ORDINANCE NO. 215

AN ORDINANCE OF THE TOWN OF ST. PAUL, TEXAS, ADOPTING THE 2015 INTERNATIONAL BUILDING CODE, THE 2015 INTERNATIONAL RESIDENTIAL CODE, THE 2015 INTERNATIONAL ENERGY CONSERVATION CODE, THE 2014 NATIONAL ELECTRICAL CODE, THE 2015 INTERNATIONAL PLUMBING CODE, THE 2015 INTERNATIONAL MECHANICAL CODE, THE 2015 INTERNATIONAL FUEL GAS CODE, THE 2015 INTERNATIONAL PROPERTY MAINTENANCE CODE AND THE 2015 INTERNATIONAL FIRE CODE; PROVIDING FOR THE REPEAL OF ALL ORDINANCES IN CONFLICT; PROVIDING A SEVERABILITY CLAUSE; PROVIDING FOR A PENALTY OF FINE NOT TO EXCEED THE SUM OF TWO THOUSAND DOLLARS (\$2,000.00) FOR EACH OFFENSE; AND PROVIDING AN EFFECTIVE DATE.

Figure R602.6.1 Top Plate Framing to Accommodate Piping shall be deleted in its entirety and the following figure shall be inserted in its place:

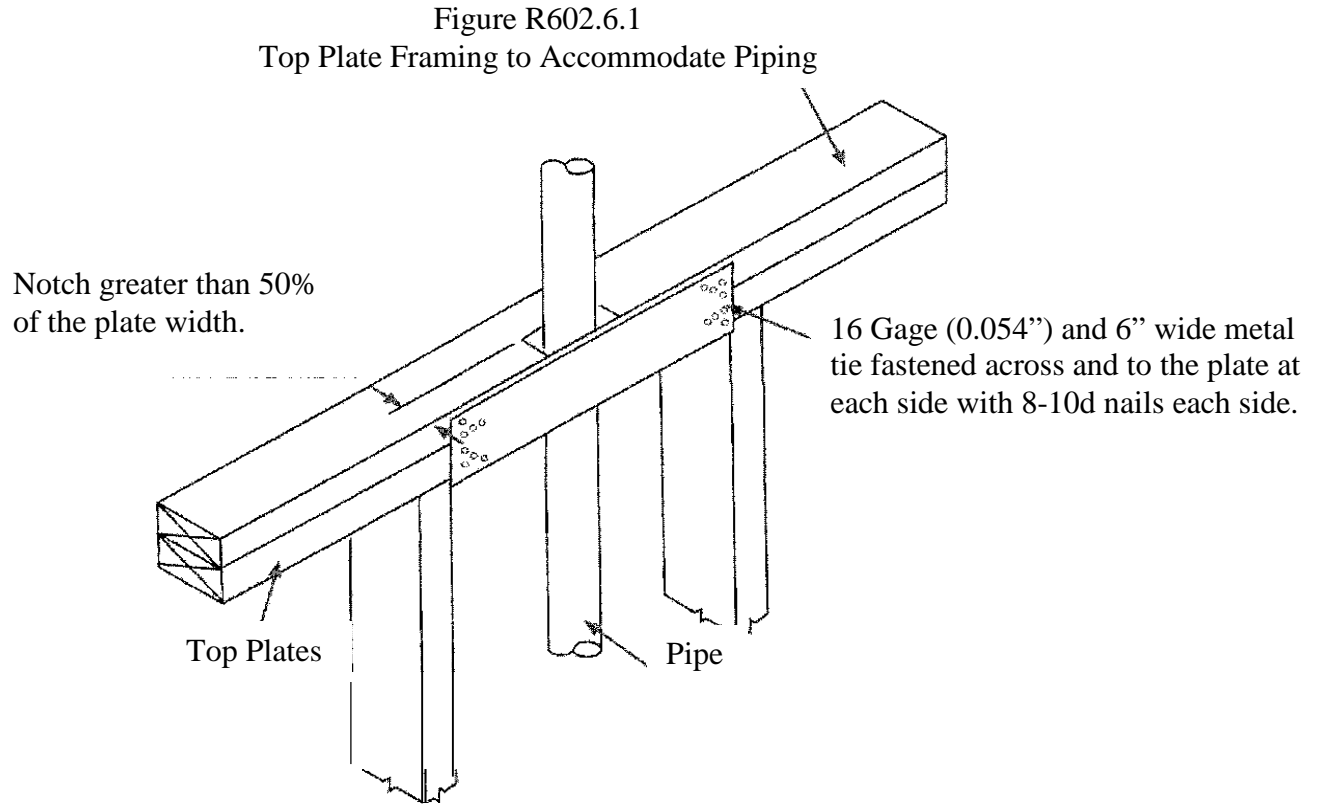
R602.6.1 Drilling and notching of top plate. When piping or ductwork is placed in or partly in an exterior wall or interior load-bearing wall necessitating cutting, drilling or notching of the top plate by more than 50 percent of its width, a galvanized metal tie not less than 0.054-inch thick and 5 inches wide shall be fastened across and to the plate at each side of the opening with not less than eight 10d (0.148-inch diameter) nails having a minimum length of 1 inches at each side

or equivalent. Fasteners will be offset to prevent splitting of the top plate material. The metal tie must extend a minimum of 6 inches past the opening. See figure R602.6.1 below.
